Re: Addendum Number 1

RFP C1672 - Feldman Center Waterside Economizer

227 WEST 27TH STREET
NEW YORK, NY 10001
NEW WATERSIDE ECONOMIZER

M-701.00

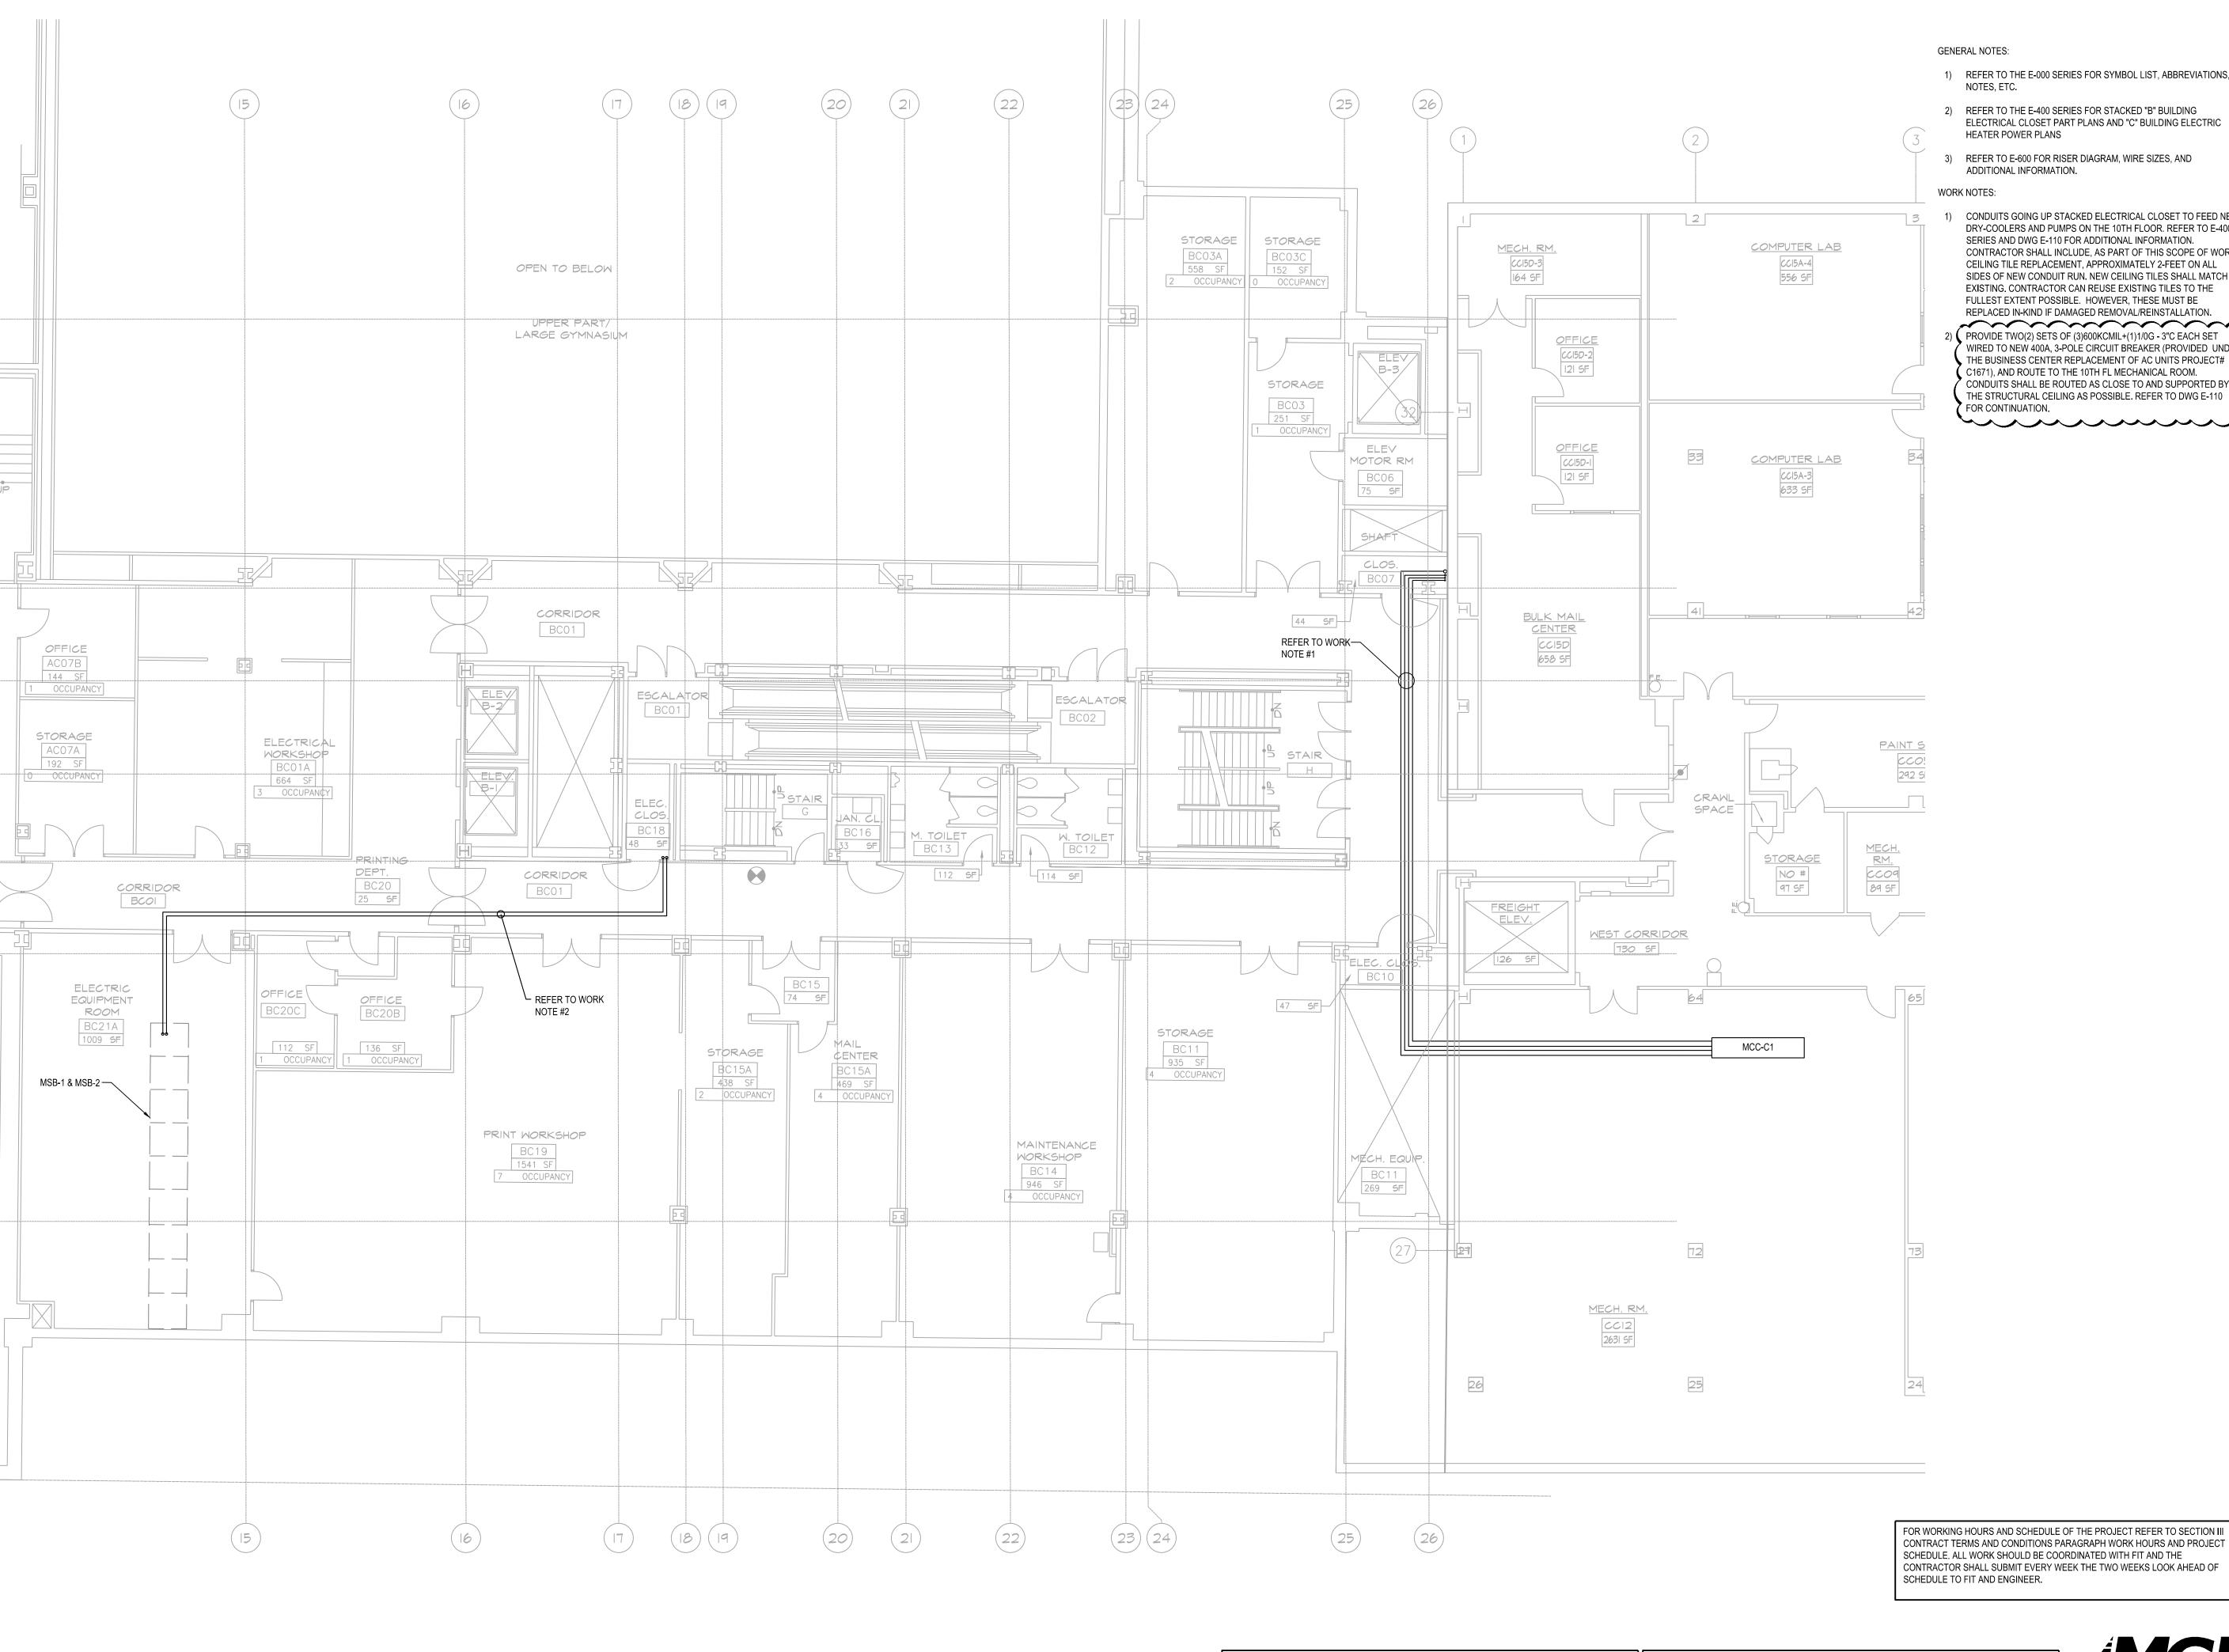
- 14. On Drawing M701 the Dry Cooler Schedule some of the Notes are not applicable please update all the notes so there is no confusion.

A: See addendum for applicable dry cooler schedule notes.

1 PROVIDE DIRECT DRIVE SUPPLY FAN

2 ALL SYSTEMS SHALL BE 40% PROPLYENE GLYCOL SOLUTION

3 PROVIDE DISCONNECT SWITCH PER DRY COOLER

CELLAR ELECTRICAL POWER PLAN

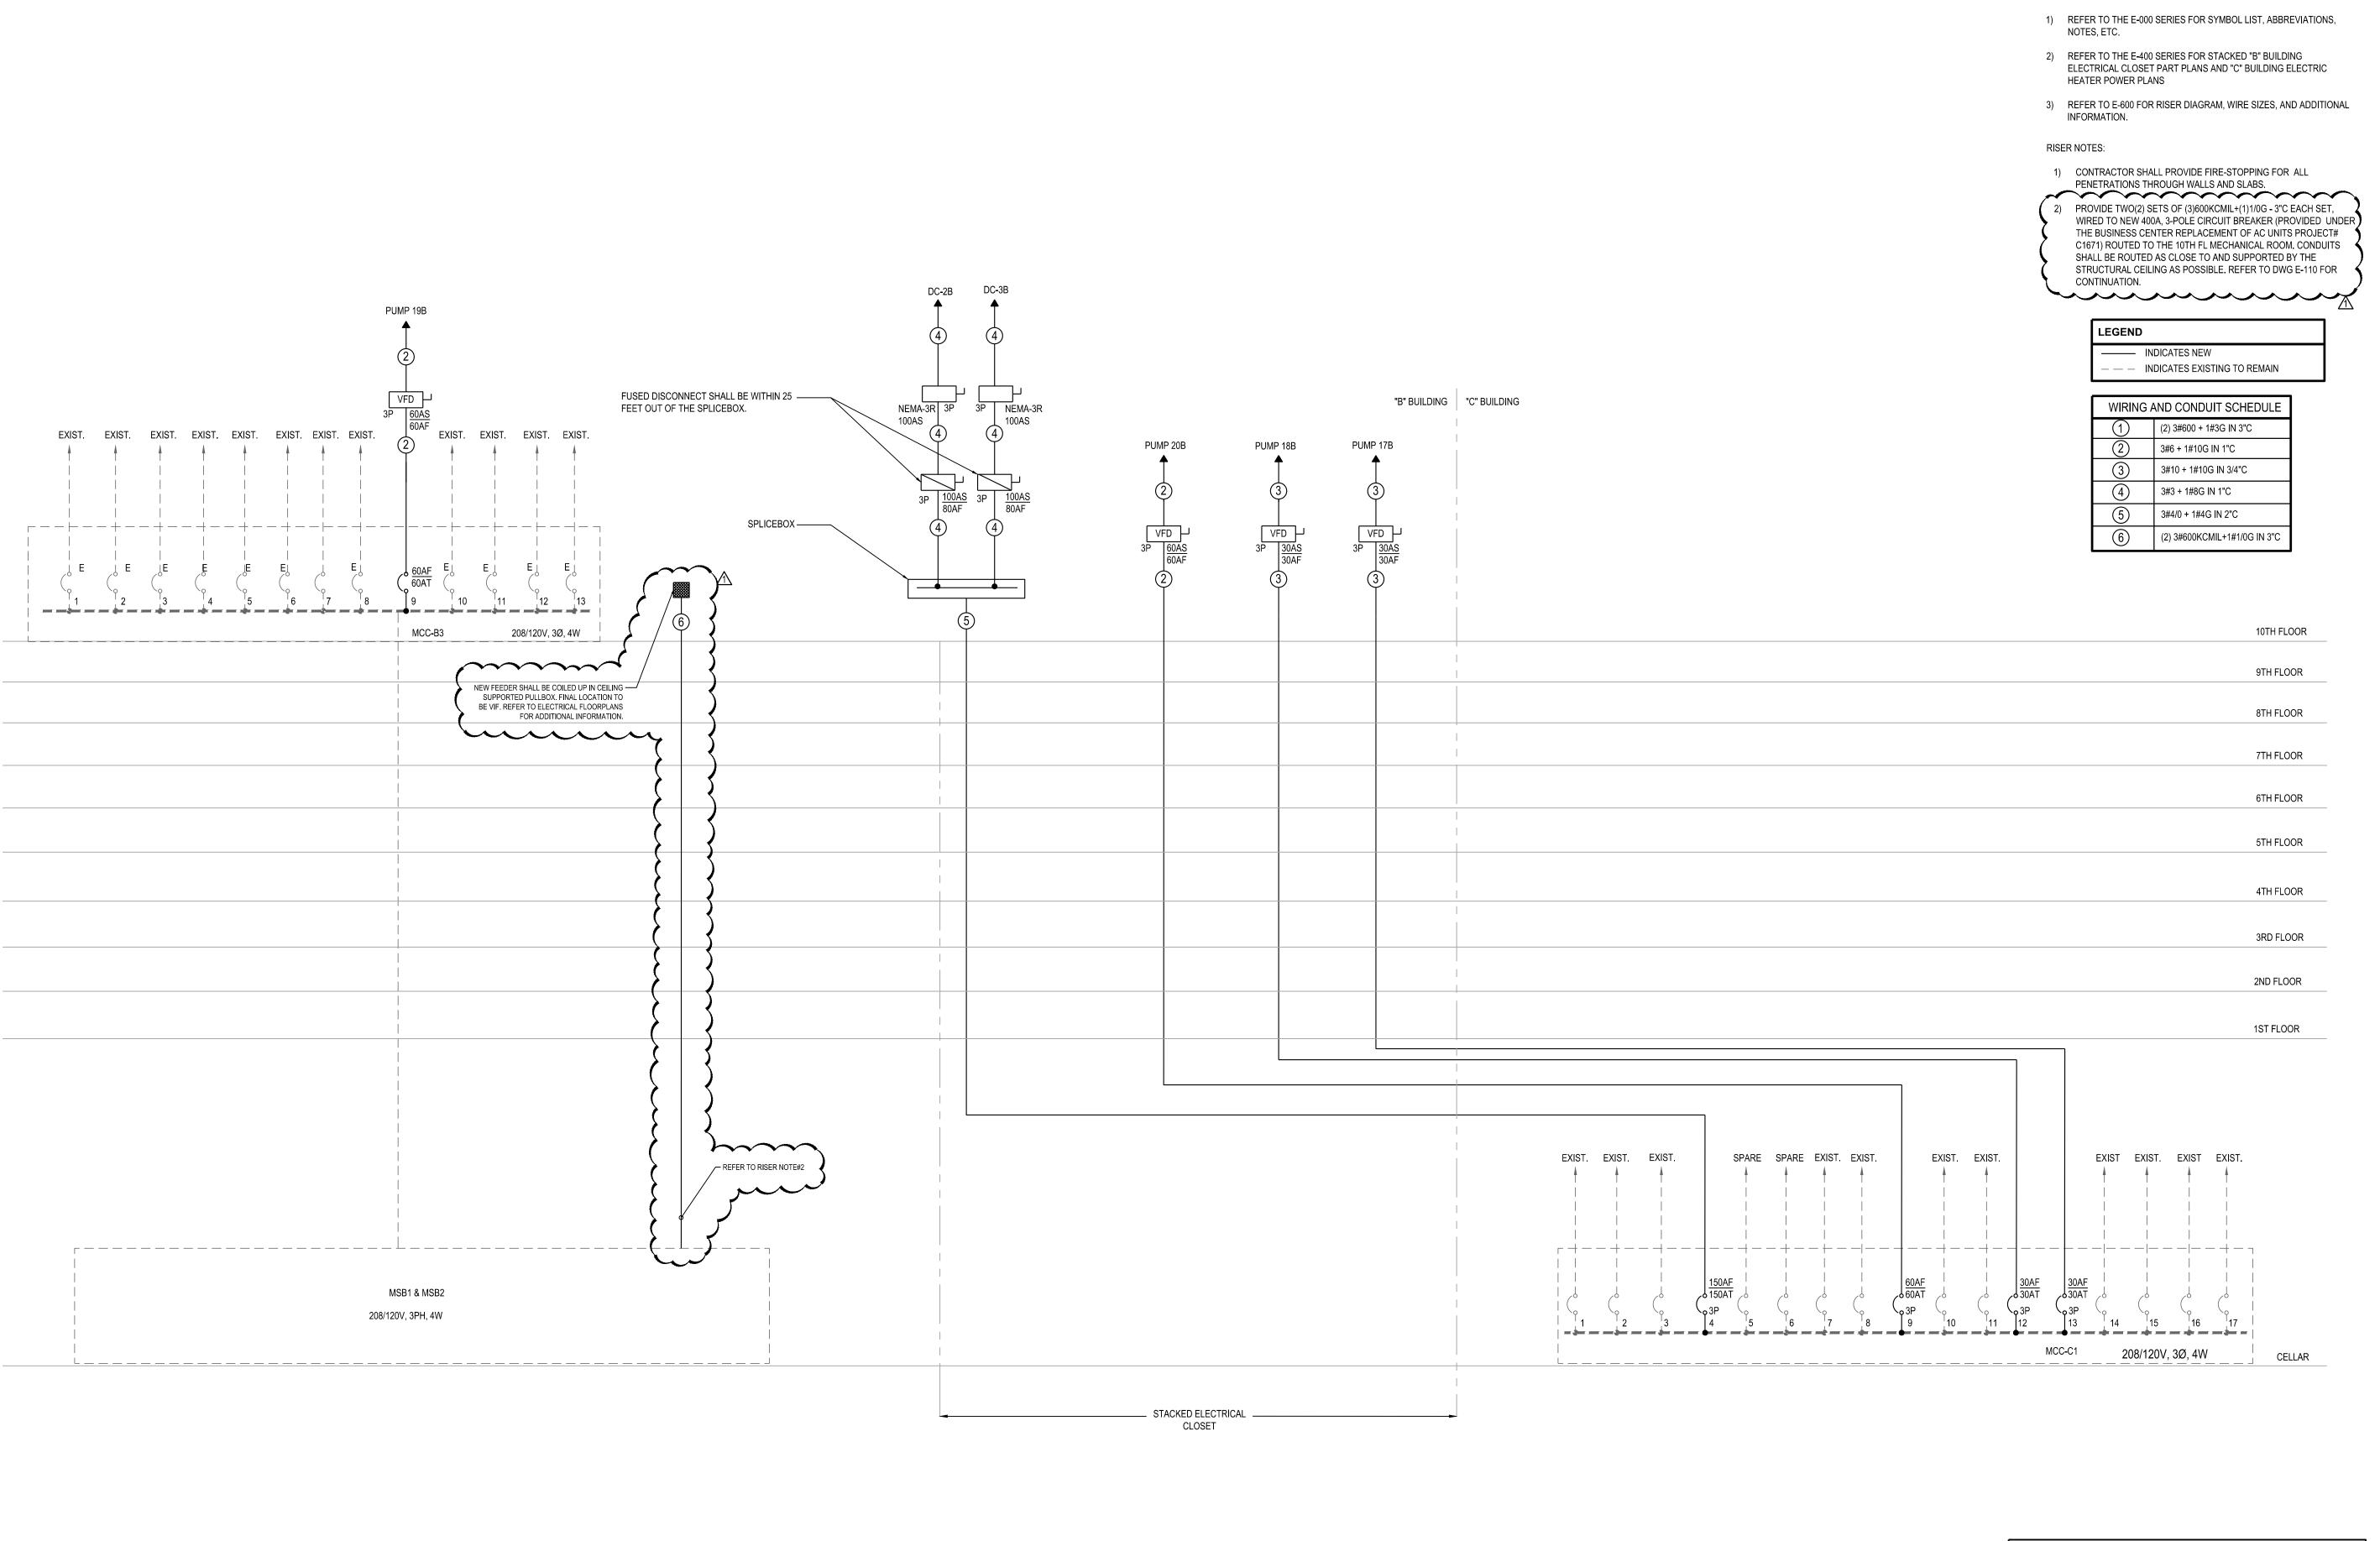
- 3) REFER TO E-600 FOR RISER DIAGRAM, WIRE SIZES, AND
- CONDUITS GOING UP STACKED ELECTRICAL CLOSET TO FEED NEW DRY-COOLERS AND PUMPS ON THE 10TH FLOOR. REFER TO E-400 SERIES AND DWG E-110 FOR ADDITIONAL INFORMATION. CONTRACTOR SHALL INCLUDE, AS PART OF THIS SCOPE OF WORK, CEILING TILE REPLACEMENT, APPROXIMATELY 2-FEET ON ALL SIDES OF NEW CONDUIT RUN. NEW CEILING TILES SHALL MATCH EXISTING. CONTRACTOR CAN REUSE EXISTING TILES TO THE FULLEST EXTENT POSSIBLE. HOWEVER, THESE MUST BE REPLACED IN-KIND IF DAMAGED REMOVAL/REINSTALLATION.  $\sim\sim\sim\sim\sim$

- PROVIDE TWO(2) SETS OF (3)600KCMIL+(1)1/0G 3"C EACH SET WIRED TO NEW 400A, 3-POLE CIRCUIT BREAKER (PROVIDED UNDER THE BUSINESS CENTER REPLACEMENT OF AC UNITS PROJECT# C1671), AND ROUTE TO THE 10TH FL MECHANICAL ROOM. CONDUITS SHALL BE ROUTED AS CLOSE TO AND SUPPORTED BY THE STRUCTURAL CEILING AS POSSIBLE. REFER TO DWG E-110
